STAFF REPORT AND RECOMMENDATION TO THE DESIGN COMMISSION

CASE FILE: LU 18-119030 DZ
PC # 17-249519
Wells Fargo Center Alterations
REVIEW BY: Design Commission
WHEN: Thursday, May 3, 2018, 1:30 PM
WHERE: 1900 SW Fourth Ave., Room 2500B
Portland, OR 97201

TOWER - PROPOSED - 5TH ST - ELEVATION - NO COLOR C12
 DESIGN REVIEW APPLICATION: LU 18-119030 DZ

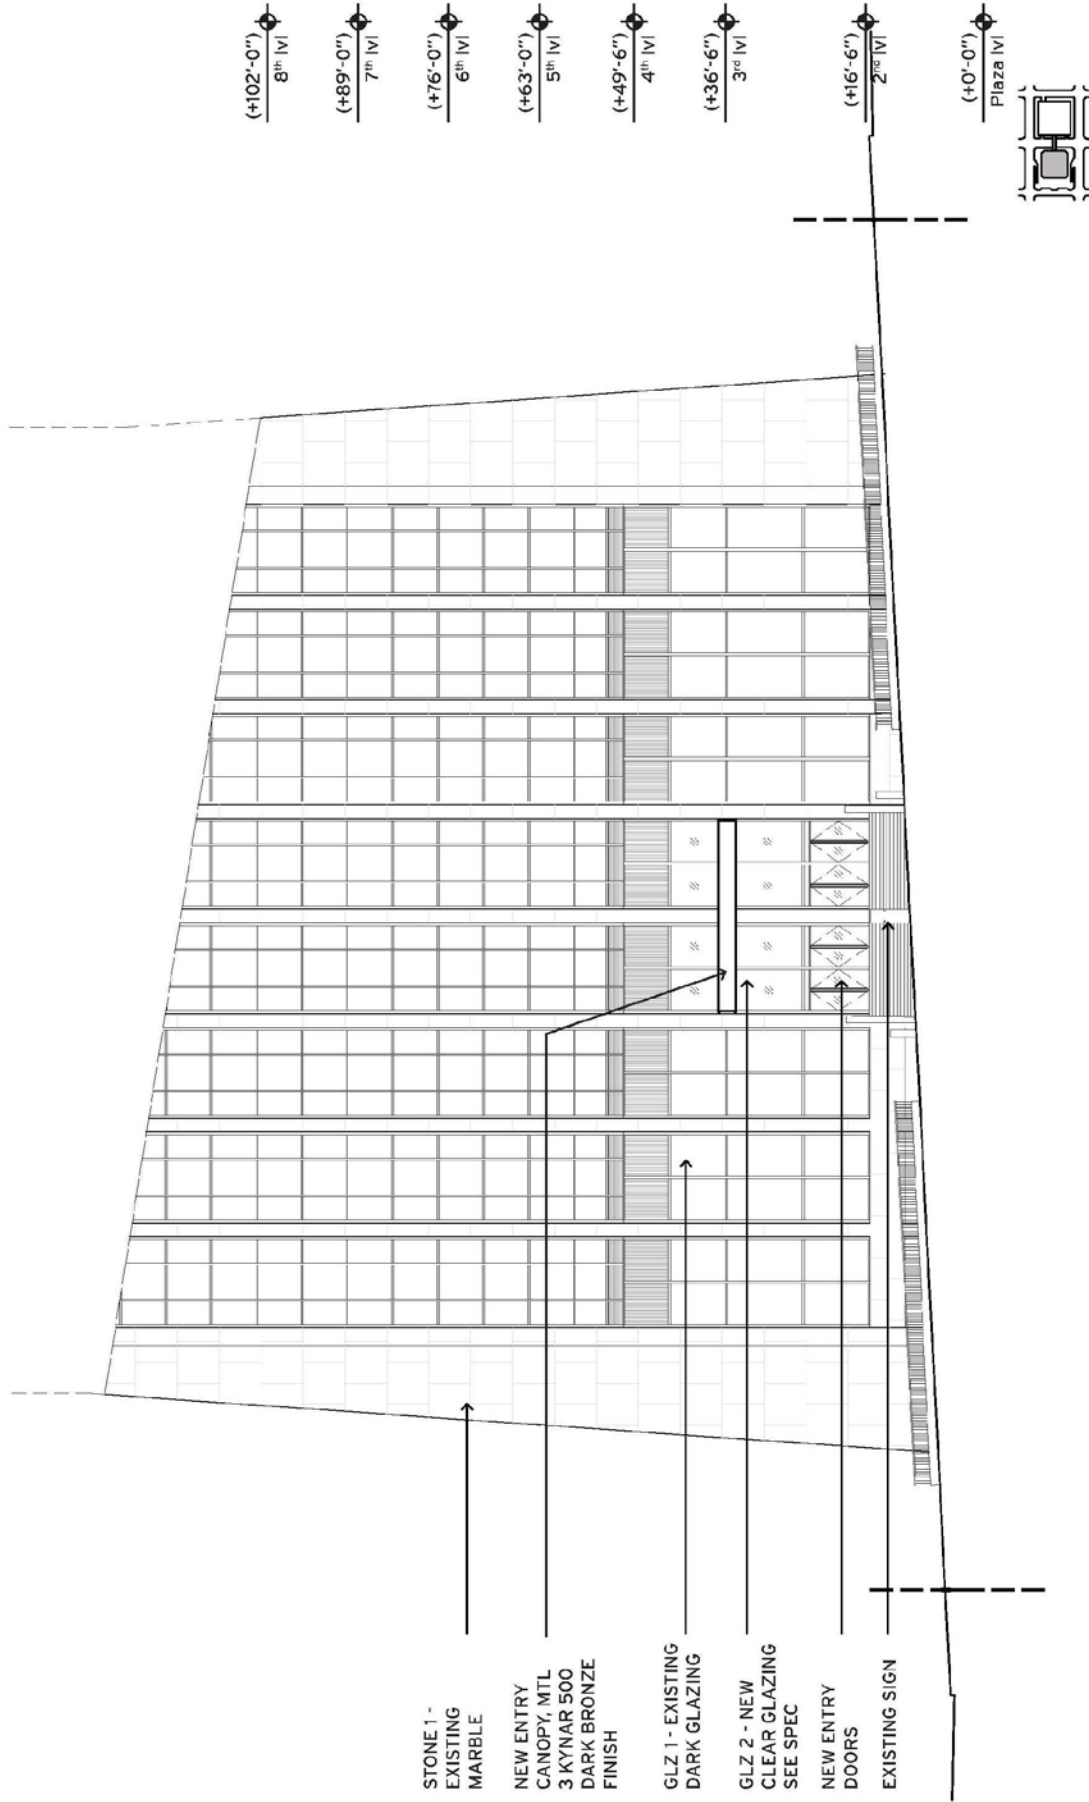
As the tallest building in the City of Portland and the State of Oregon, the Wells Fargo tower is a very high-profile building that plays a key role in defining the character of downtown. Proposed alterations must be compatible with- and derive from- the same architectural language established by the original building. At the project's DAR, the unanimous opinion of the Design Commission was that the entry alterations proposed for the 5th Ave side of the tower were not compatible with the building and therefore not yet supportable.

Following the DAR, the awning design progressed a great deal to become more sympathetic to the building's architecture. *Staff feels that despite the positive direction, the proposed canopy configuration is not yet approvable. The entry's scale and expression have moved closer to the Commission's clear direction to honor the original architecture of the building; however, the proposal will remove part of the building's character-defining sloped windows, replacing them with vertical glazed panels. In addition, the existing canopy better aligns with a meaningful datum in the base expression than does the proposed which interrupts the verticality of the building and interrupts the sloped window expression. Further, the illumination proposed within the canopy results in a canopy design that not fit the character of the building. The proposed canopy has the characteristics of an internally illuminated sign cabinet and thus lacks the lightness and elegance found in many canopies around the City. The proposed design has a chunky aesthetic that would distract from the building's existing vertical architectural expression and would not allow views up along the piers as would a transparent option.*

In response to staff feedback, the applicant's plan set includes the applicant's preferred canopy option (C11-15, APP.101-104) as well as an additional three options: Alt-1 (C16-17, APP.105-108), Alt-2 (C18-19, APP.109-112), Alt-3 (C20-21, APP.113-116). Of them, only the second option, "Alt-2", preserves the tilted glass feature of the building, however, despite the transparency introduced in "Alt-1" and "Alt-2", staff finds that the canopy framing of these options is too chunky and incompatible. While "Alt-3" is moving towards being a compatible canopy design, the current configuration still removes the building's character defining tilted windows and does not maintain the lower datum. Staff believes it is essential to retain the building's unique base expression and thus the retention of slanted glass must be part of the final design. An issue raised in a letter from the City of Portland Historic Landmarks Commission in response to the Design Advice Request held for the proposal and echoed by the design commissioners during that hearing, is that retaining the building's original character would be possible only if any changes made are reversible. The removal of the tilted/canted windows may not be an easily reversed alteration.
